Arlington – DPW Facility
WSE Project No. 2170997

**Re: *Environmental Design Review
Arlington Municipal Facility
49 and 51 Grove Street***

On behalf of the Town of Arlington, Weston & Sampson Engineers, Inc. is hereby enclosing supplemental information for the above project in response to the comments received at the February 22, 2021 Arlington Redevelopment Board meeting. Below is a summary of the questions raised at the meeting with the associated responses. Support documentation has been attached to this letter to supplement the responses below.

5 BIKE RACK DETAIL

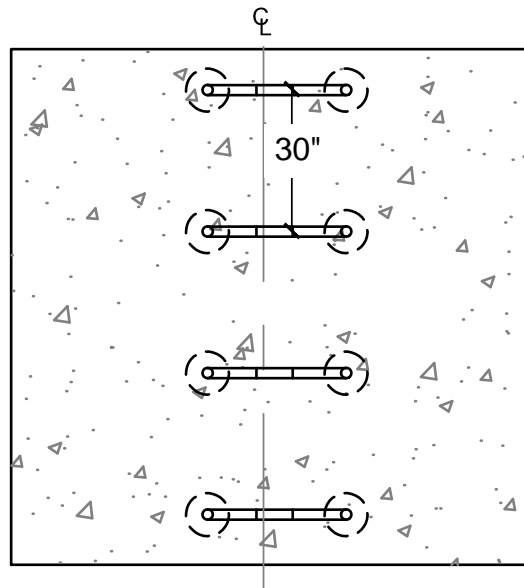
Comment 1: The Arlington Redevelopment Board (ARB) indicated that the exterior “Wave” bicycle rack is not compliant with the Town’s Bike Rack Guidelines. The Town requested that Weston & Sampson review the guidelines and provide bicycle racks which meet these guidelines.

Response 1: The proposed bicycle rack’s shape and layout has been revised to a standard “U-Shape” in compliance with the Town of Arlington’s “Bicycle Parking Guidelines”. Please see associated reference sketch attached to this letter.

LAYOUT REVIEW OF 8' WIDE ACCESSIBLE PARKING SPACE

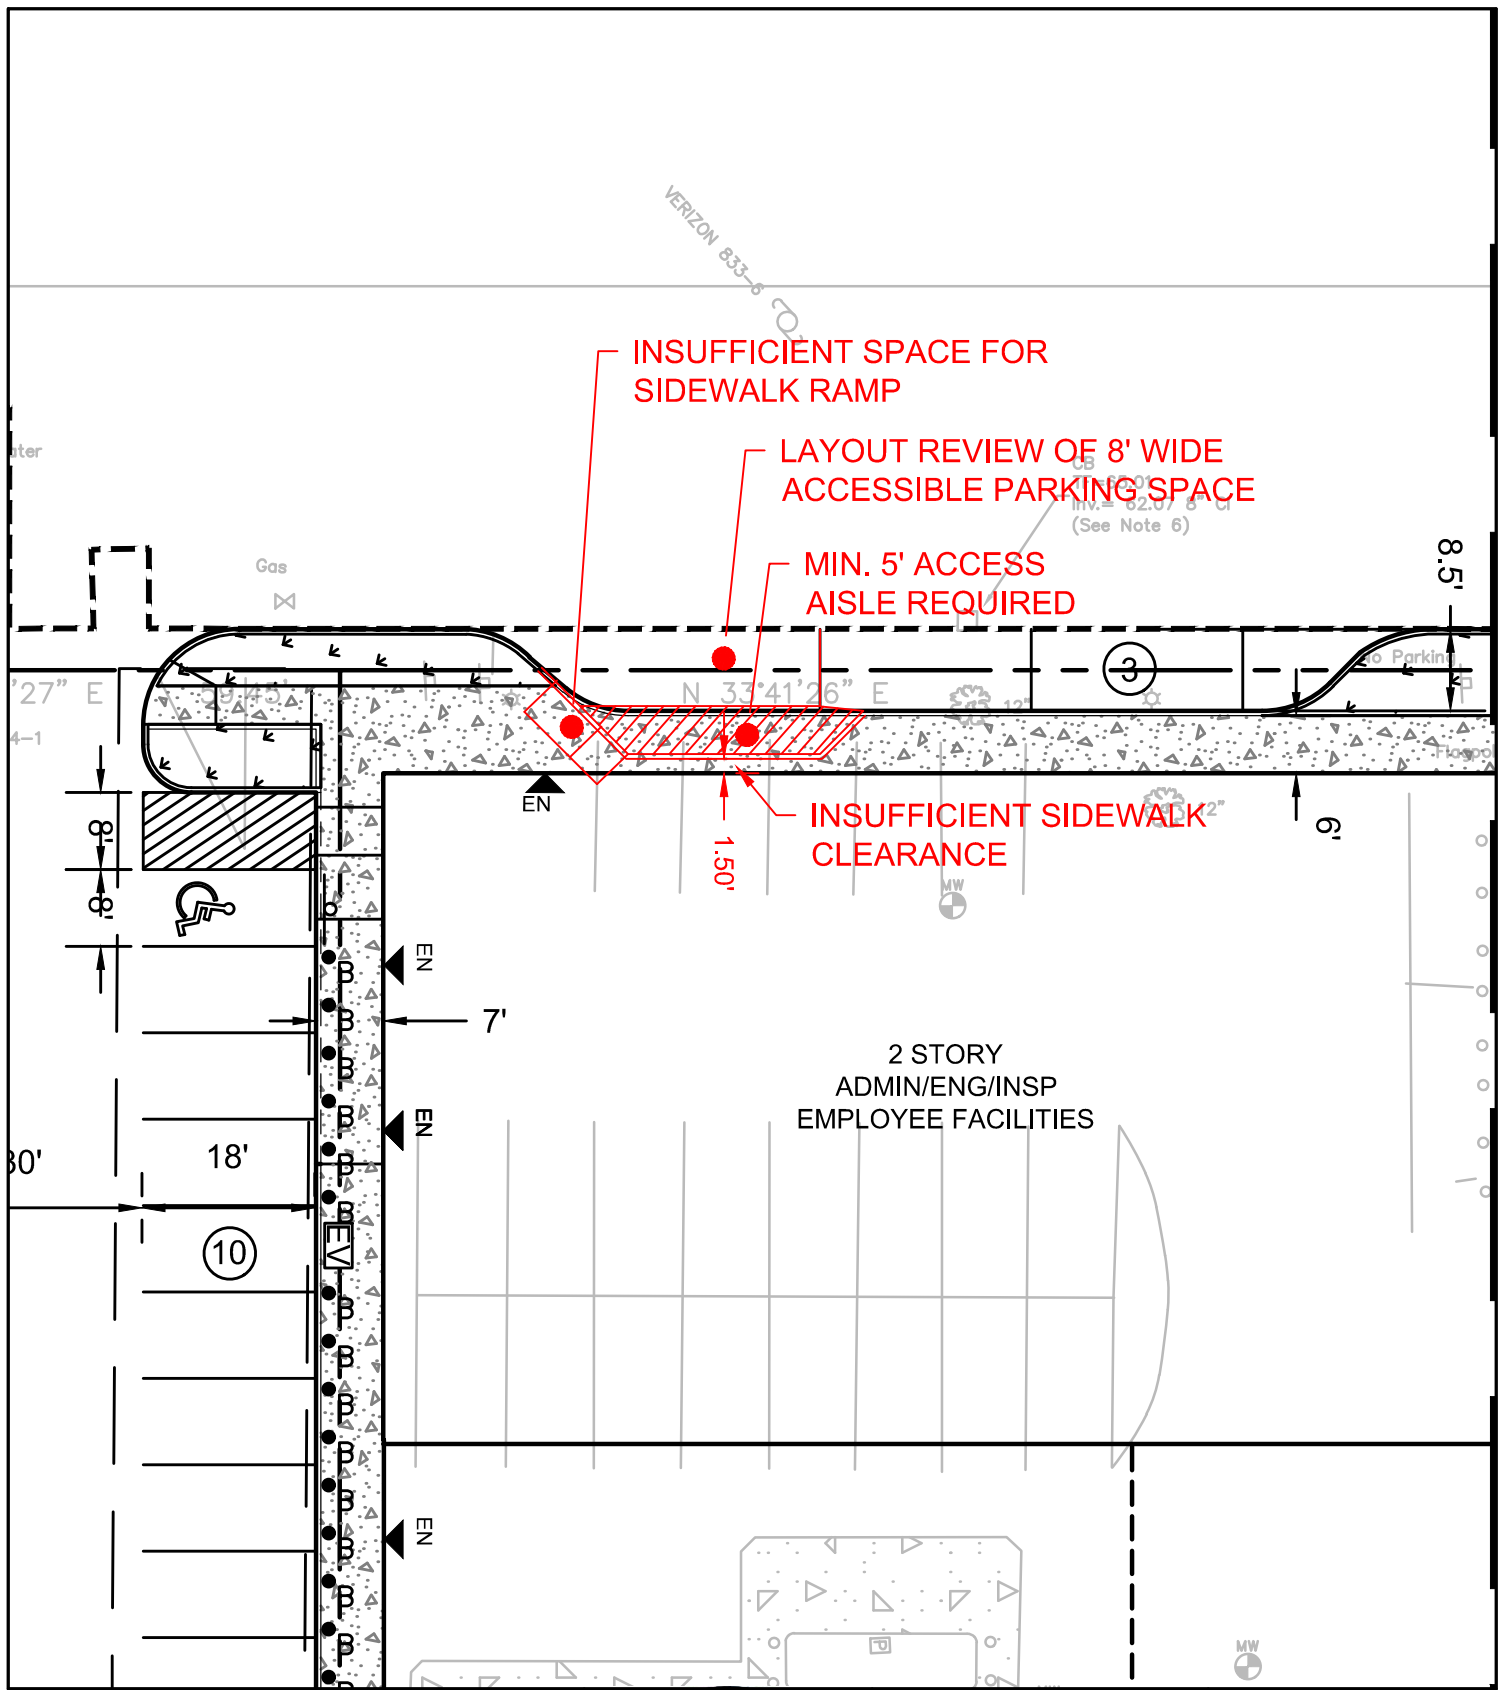
Comment 2: The ARB requested that one of the parking spaces along Grove Street be changed to a handicap parking space. Weston & Sampson to review if there is adequate space to provide a code compliant handicap parking space on Grove Street.

Response 2: Due to the clearance requirements associated with an on-street accessible parking space, namely the 5-ft width aisle clearance adjacent to the space, would result in a remaining sidewalk width that is insufficient for minimum code standards. A review of relocating the building siting in order to accommodate an accessible parking space at the street location, has determined that this would negatively impact the DPW operational clearance requirements.

INSUFFICIENT SPACE FOR SIDEWALK RAMP

MIN. 5' ACCESS AISLE REQUIRED

INSUFFICIENT SIDEWALK CLEARANCE

Drawing Title:
**VOLUME III,
BUILDING E**
OVERALL FLOOR
PLANS
Sheet Number:
A101

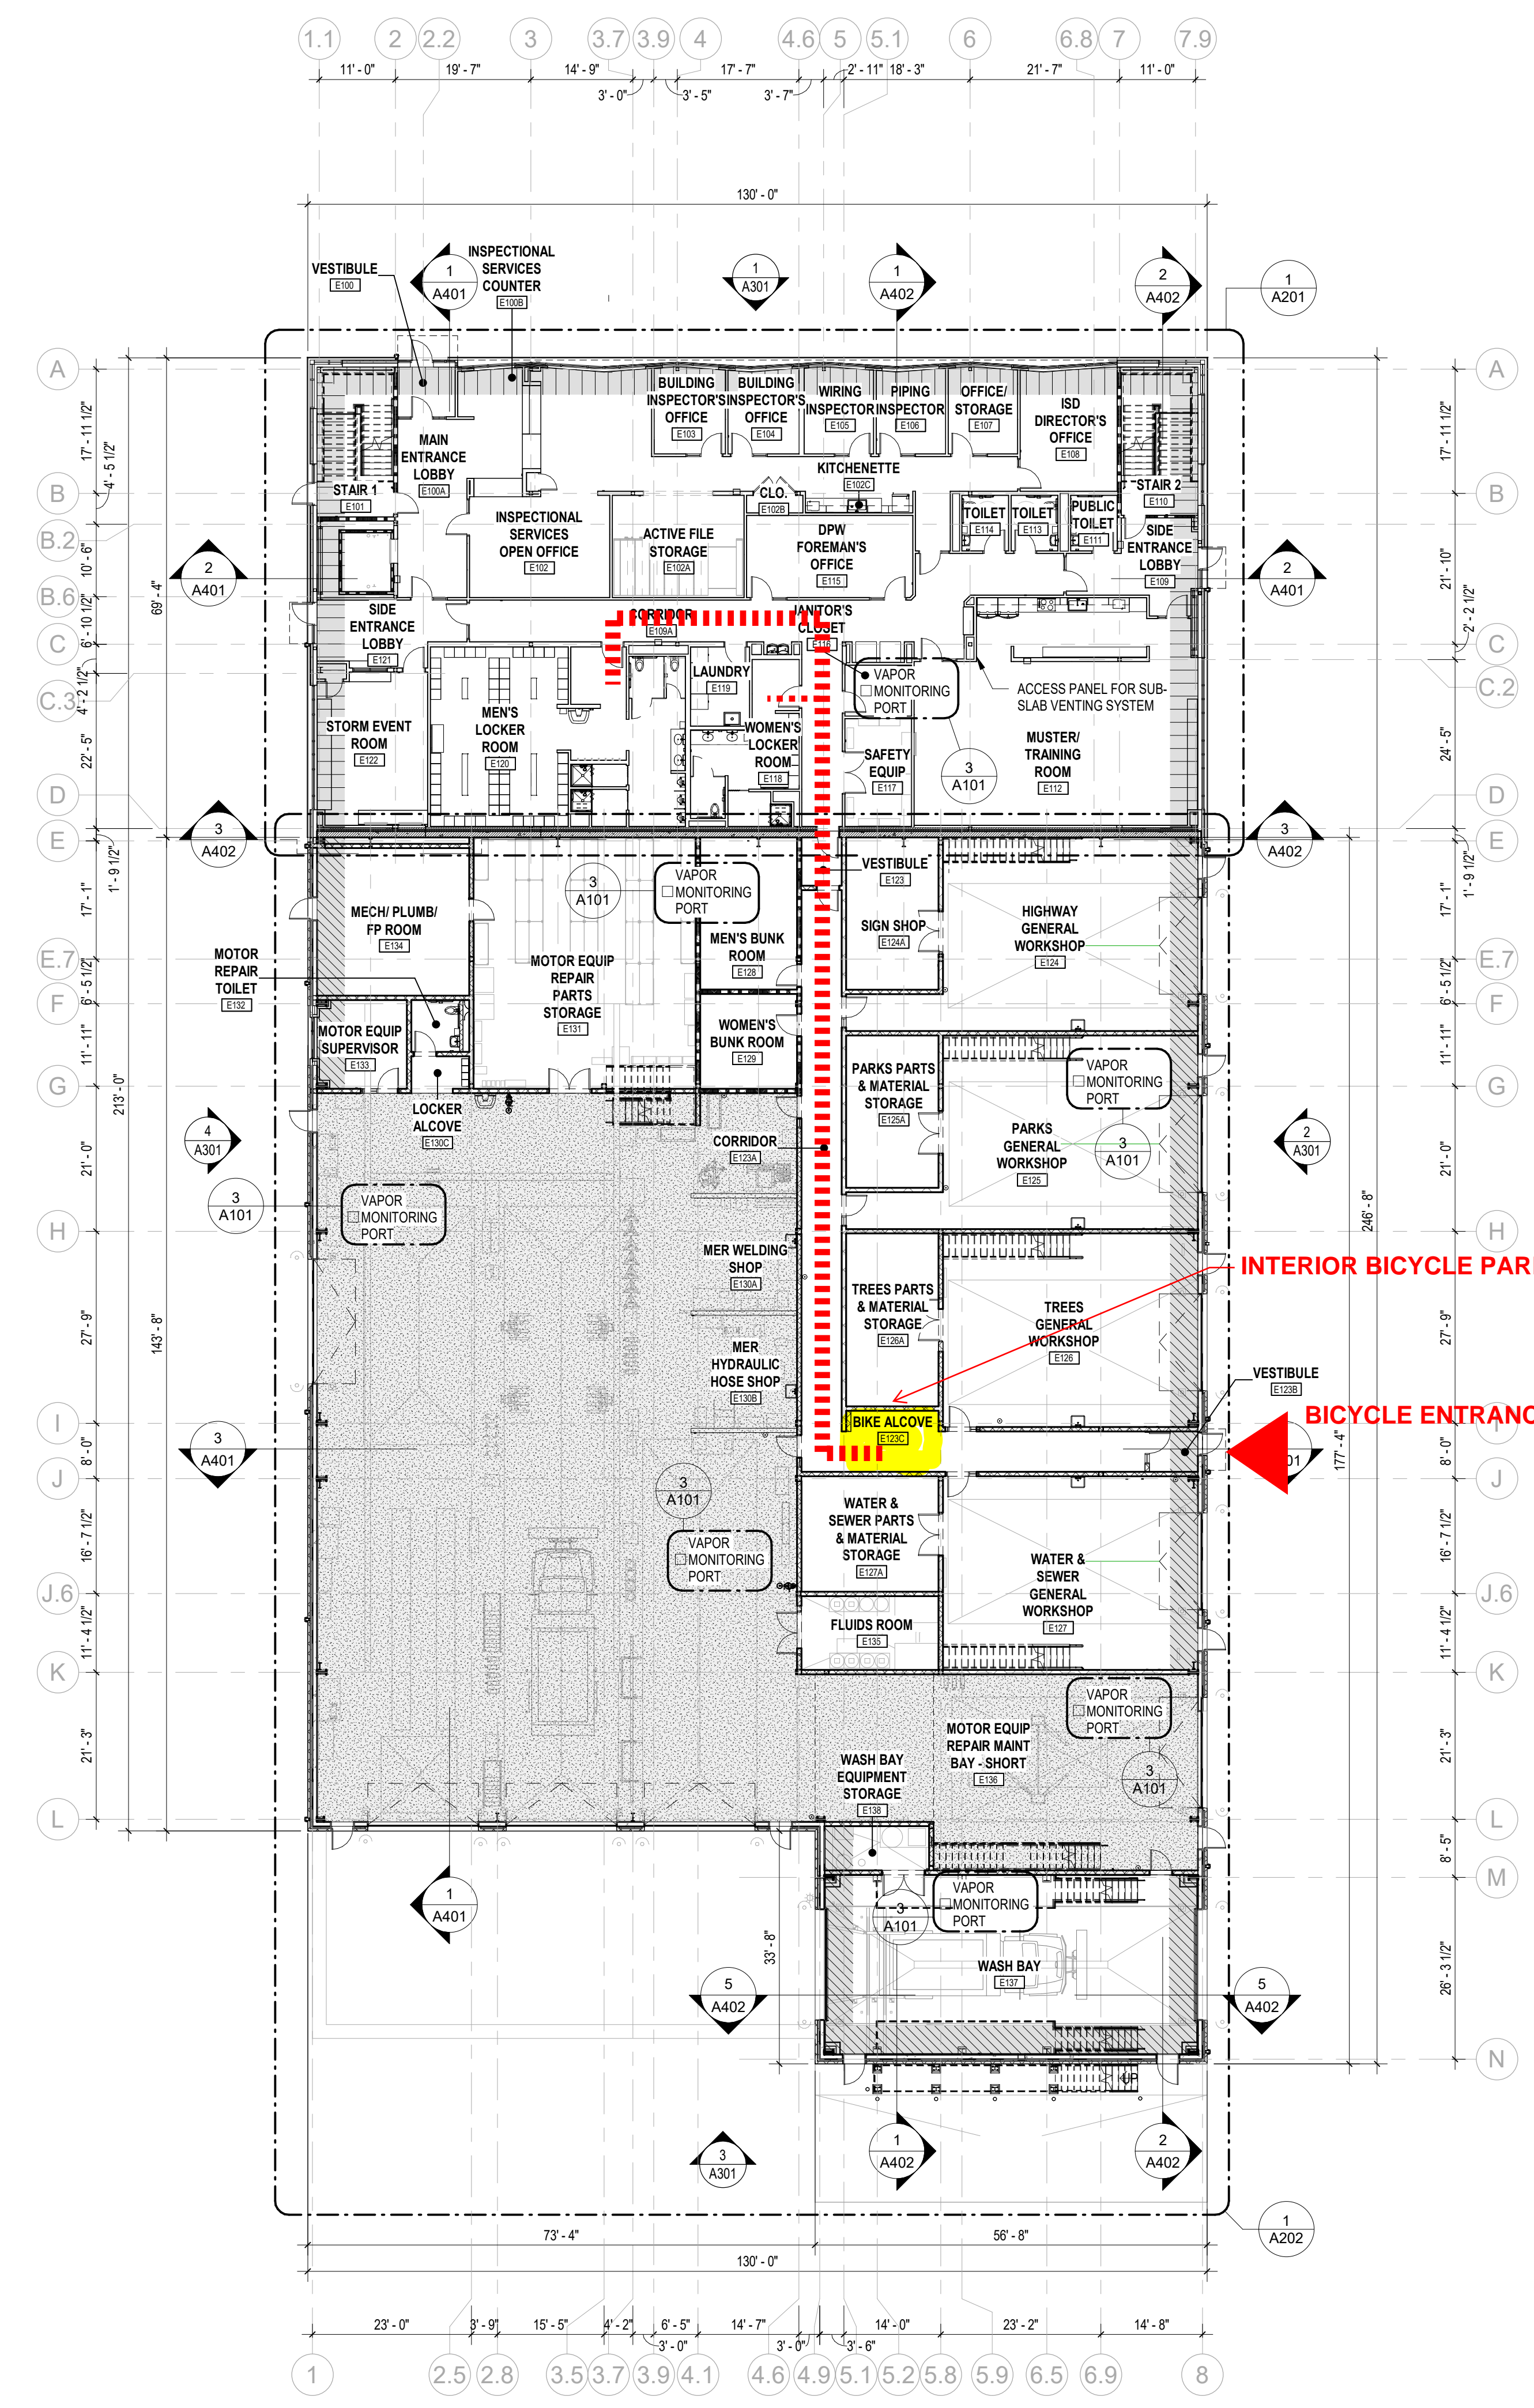
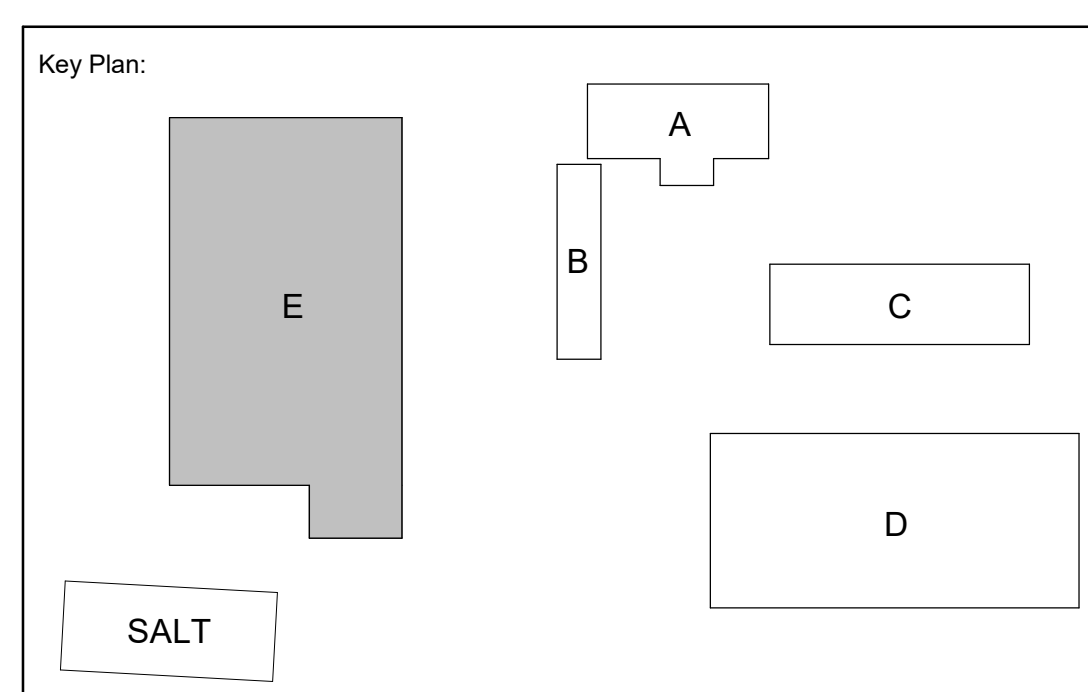
Comment 3: The ARB requested that we consider moving the location of the interior bicycle parking area closer to the administration area to allow for easy access to the shower area.

Response 3: The location of the interior bicycle parking area has been reviewed with the DPW based

on the intended use of the facility. As shown on the attached plan A101, the interior bicycle storage area is located in an alcove off the employee circulation corridor with direct access to the outside on the east side of the building. This location limits potential conflicts with staff entering/exiting via the employee pedestrian entrance on the west side of the building. This location provides direct access from the bicycle storage area to the locker/shower/toilet area as shown by the dashed red line and is within a reasonable distance for personnel using these facilities.

INTERIOR BICYCLE PARKING
BICYCLE ENTRANCE

Free-standing Facility Monument Sign

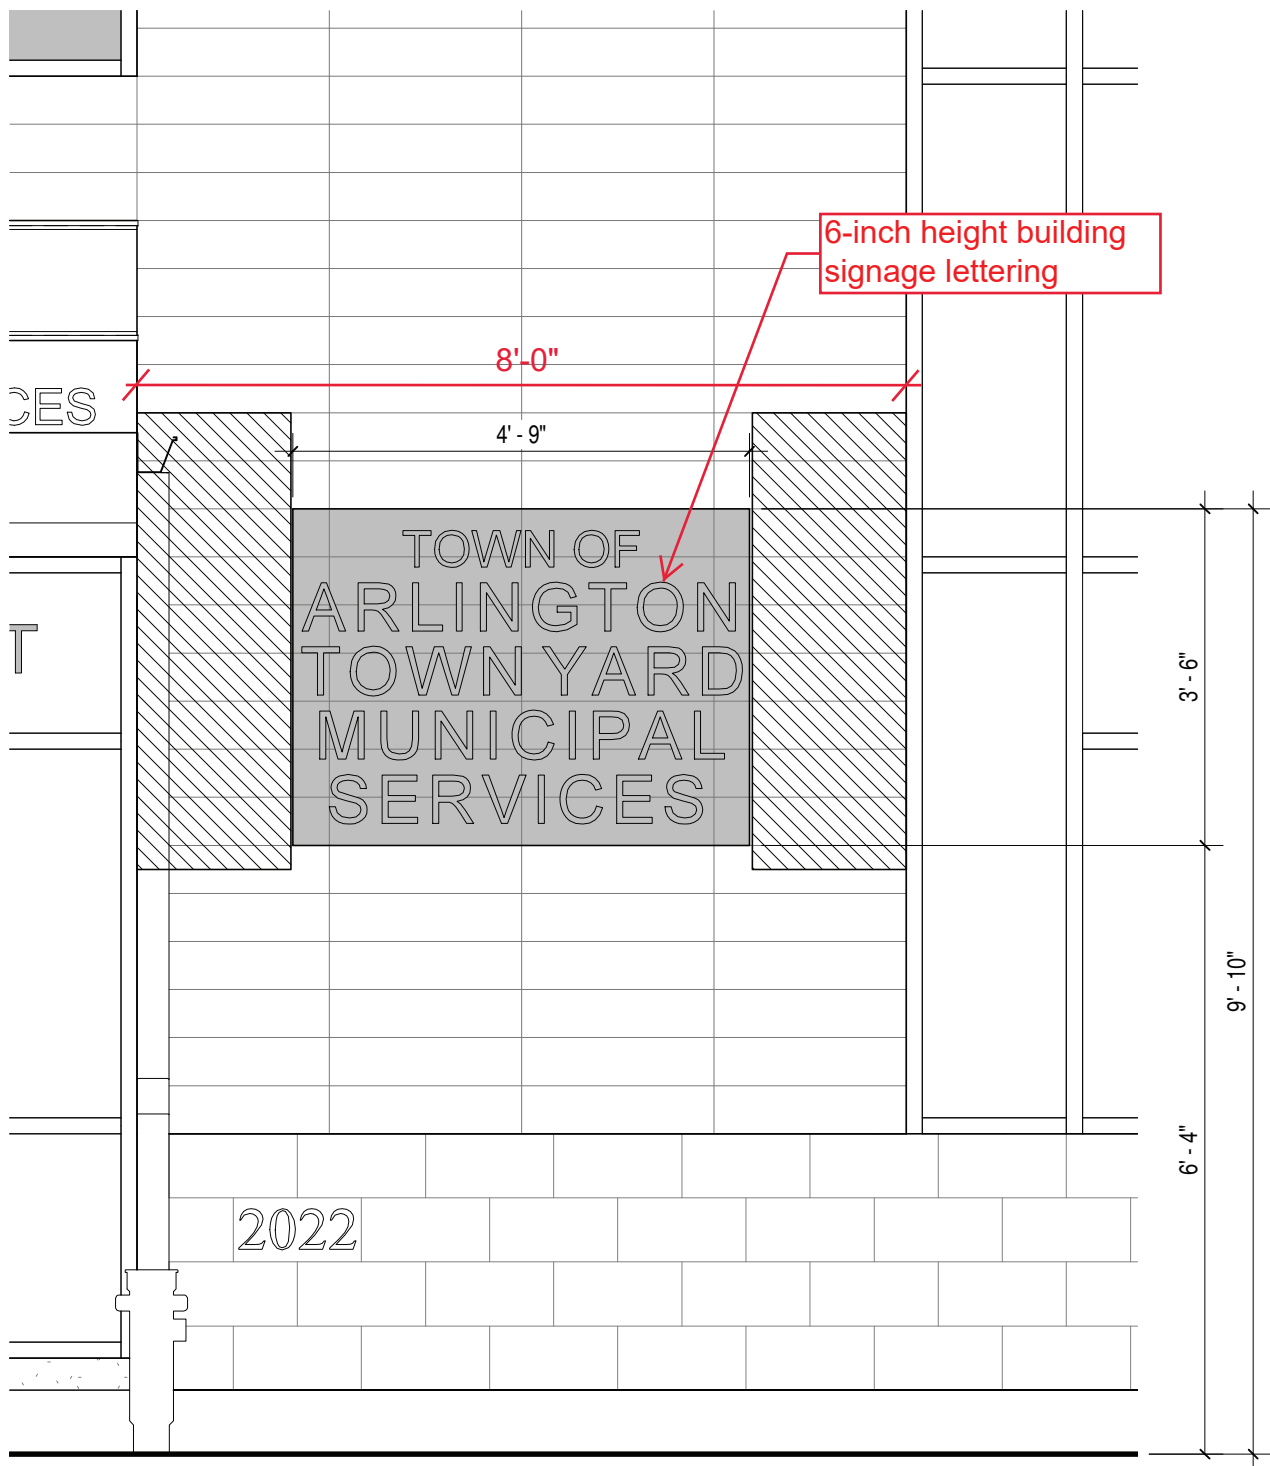
Comment 4: The ARB requested that additional details related to the proposed signage be provided demonstrating compliance with the Zoning Bylaws.

Complies with Arlington Zoning Bylaw 6-37:

- 1. One sign provided for facility**
- 2. Height of sign 4'-6", below maximum 6' height requirement**
- 3. Sign is 20-sq ft, below maximum 24-sq ft requirement**
